Re: Additional Comments PLN2021-00090 Tree Removal Miramar Drive APN 048-076-120 ("TEG Parcel")

We are writing to express concerns about the notice we received for a Coastal Significant Tree Removal Permit application (PLN2021-00090) for a vacant parcel in unincorporated Miramar (APN: 048-076-120) in a Coastal Zone and a Scenic Corridor. We live at 655 Miramar Drive (APN: 048-076-130). The permit is to remove nine trees, one DBH Monterey Pine, and eight DBH Tasmanian Blue Gum eucalyptus. We are concerned about this permit for the following reasons:

Figure 1: Area of Focus

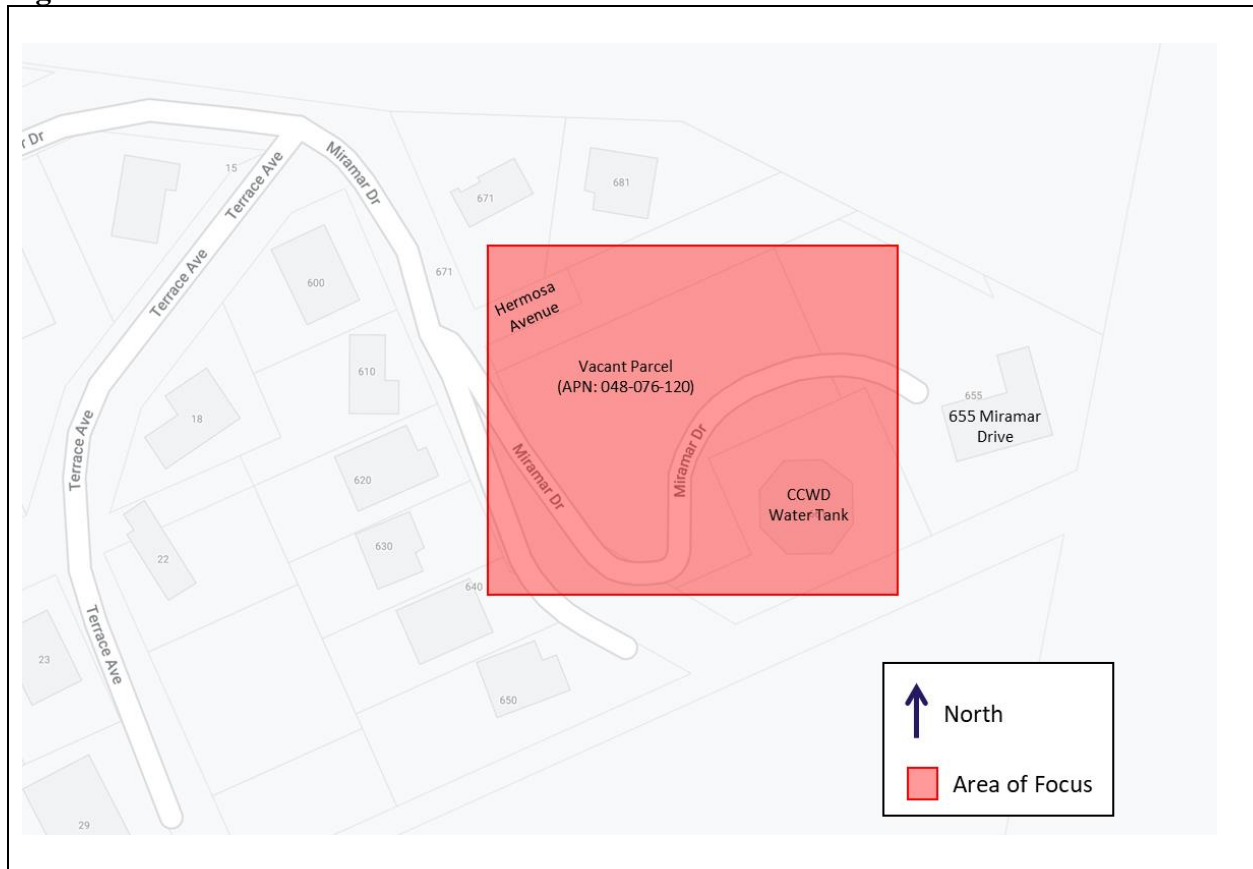
1. **The permit does not address any of the ten dead trees on the vacant parcel.** We are concerned that the owners of APN: 048-076-120 did not apply for a permit to remove any of the ten dead trees on their vacant parcel. On January 19, 2021, during a rainstorm, a dead tree fell close to our fence (see Figure 3). Fortunately, there was no damage, but we are concerned that the remaining dead trees are hazardous. All of the trees identified for removal are alive. We have attached a map showing the approximate location of the trees identified for removal (green indicators), dead trees on the vacant parcel (red indicators), and before and after photos of the tree that fell close to our fence (see Figures 2 and 3). Given that they claim to have an arborist report, they must know about the dead trees on their vacant parcel. We ask that the county complete an arborist evaluation and determine the risk level from the existing dead trees.

Figure 12: Trees Marked for Removal

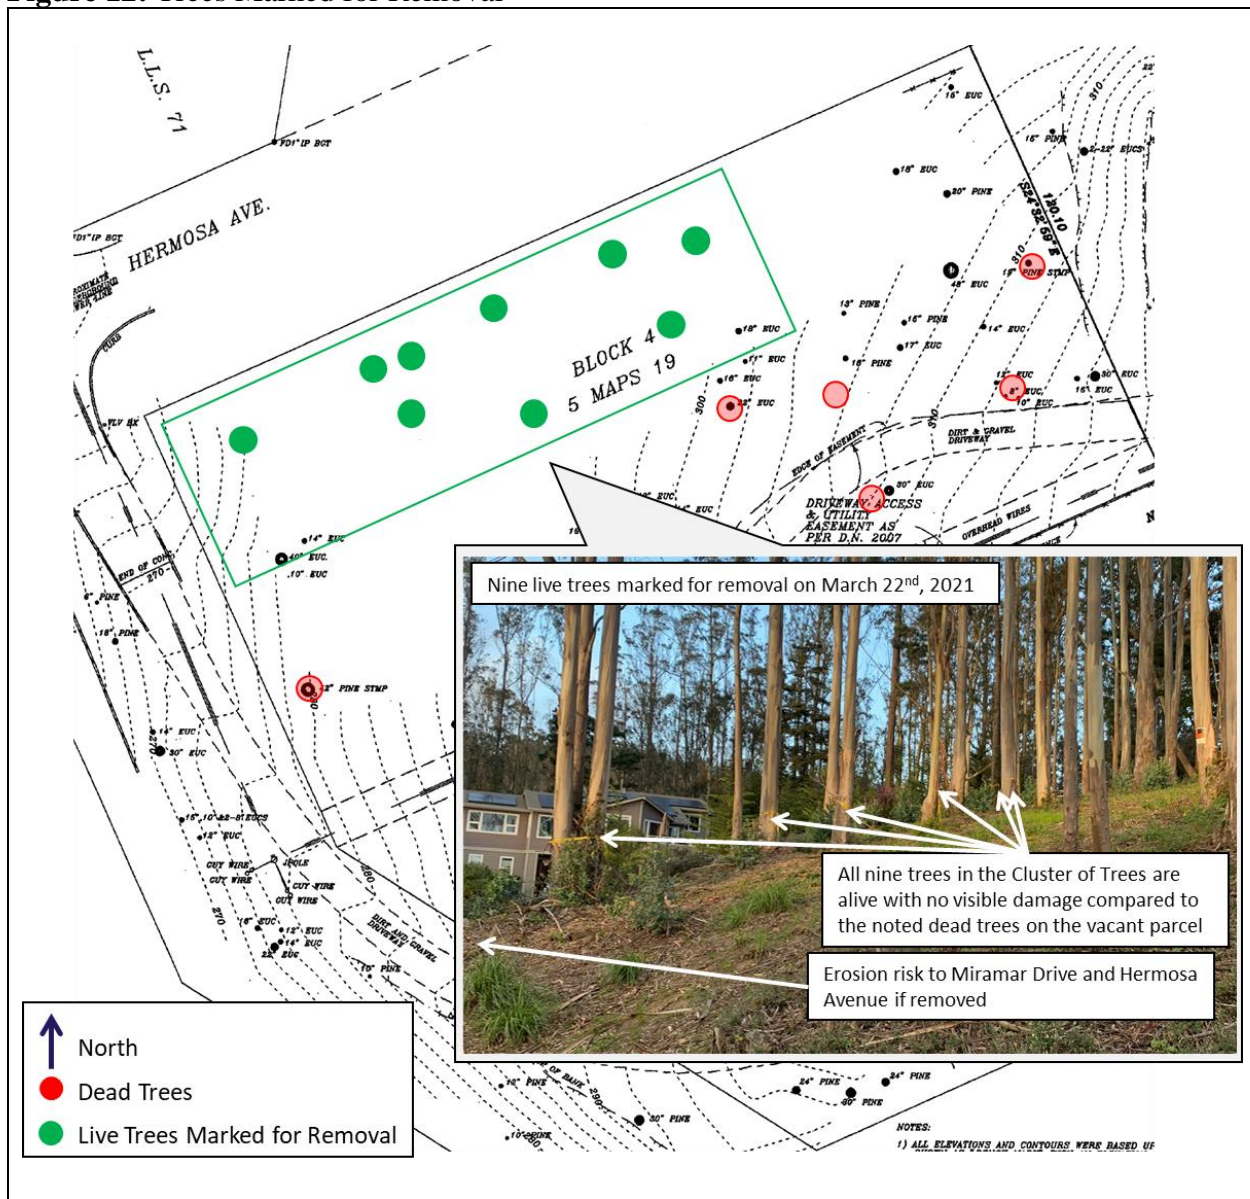
3. **Erosion concerns.** We are concerned that removing the nine trees will lead to an erosion issue that will degrade our ability to access our property and other landowners' homes. We access our property using the upper portion of Miramar Drive (see Figure 1). Based on the attached geotechnical report completed in 1991 for subdivision purposes, we know that any cutting or filling could create an unstable condition in the area; the report recommends an investigation to reduce any risk (see Figure 13). We ask that the county complete an evaluation to determine if the nine trees' removal on the vacant parcel will lead to erosion issues for upper Miramar Drive and the surrounding homes and families (see Figure 12).
